Re: Special Consent Order SOD-88-02A

On behalf of Refuse Hideaway Landfill, Inc. (RHL), we have prepared this submittal to address and comply with your June 3, 1988, letter. Enclosed are the following:

NO.	BY	DATE	REVISION	APP'D
PROJECT				
REFUSE HIWAYWAY SPECIAL CONSENT ORDER SOD-88-02A SUBMITTAL				
SHEET TITLE				
PROPOSED FINAL GRADES (REVISED)				
DRAWN BY	PRO	SCALE	1"=50'	PROJ. NO.
CHECKED BY		DATE		
APPROVED BY		DATE		
DATE	08-28-88	DRAWN BY		
SHEET NO.				Figure 1

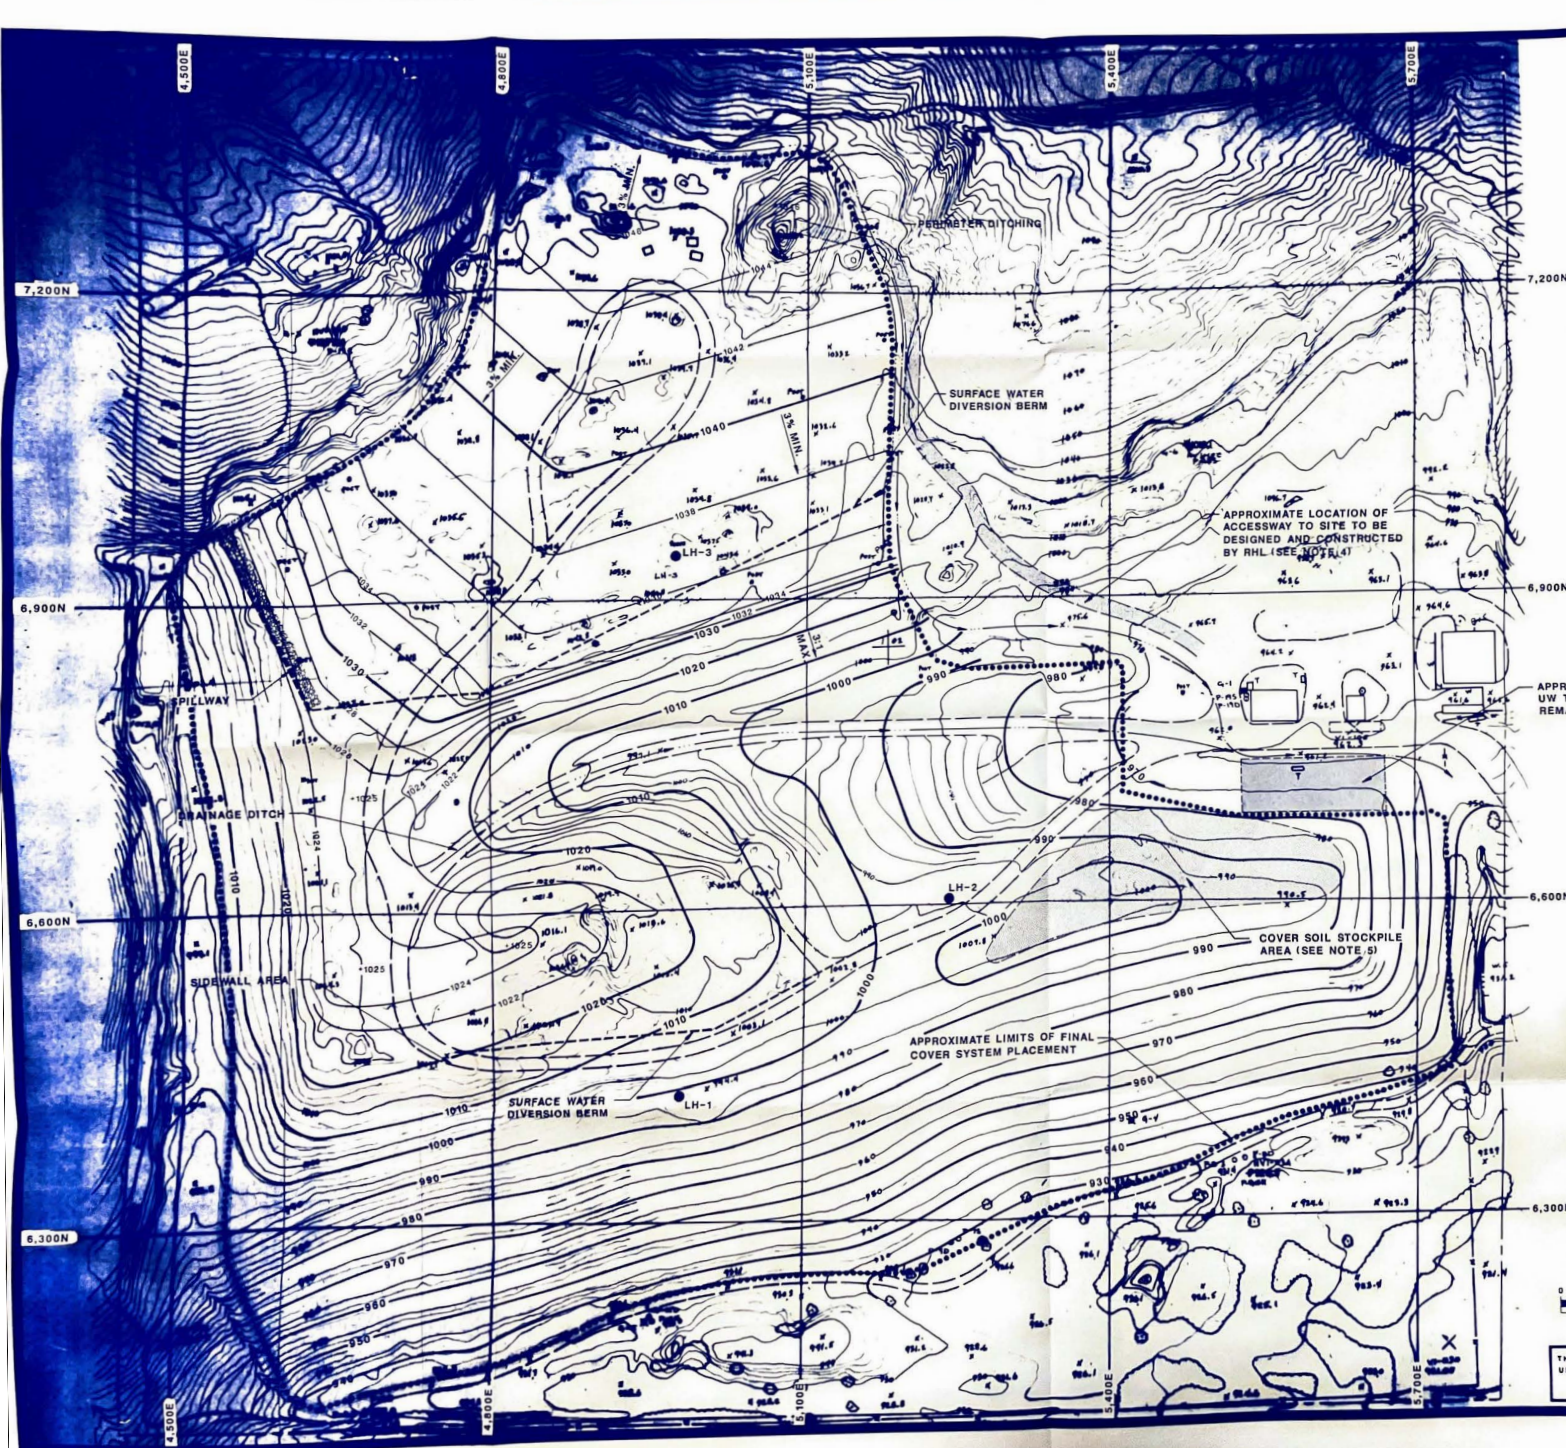
- A. A revised closure plan (per paragraph 2d of the Consent Order) showing the south and west slope covered with an NR 500 series cap (see Figure 1, Appendix A).
- B. Additional documentation of clay soils (per paragraph 2e of the Consent Order) should the south and west slopes need to be covered with the full NR 500 series proposed cap (see Appendix B). The estimated required additional clay volume required to be documented is 26,000 cubic yards (assuming a south and west closure area of 8 acres).

This submittal is being made even through RHL objects strongly on technical and regulatory grounds that the south and west slopes should be required to have an NR 500 series cap.

1. The existing cover system on the south and west slopes performs in a manner similar to that of the proposed NR 500 series cover system selected for the top areas of the landfill. Based on the analyses performed using the USEPA HELP Model, there is no technical justification (based on the issue of overall environmental improvement) for requiring the south and west slopes to be capped (see Appendix C).

The Department is requested to review and approve the original June 1, 1988 plan; or if not approval (because of lack of data) hold-off further action regarding the south and west slopes until the remedial action studies have been completed.
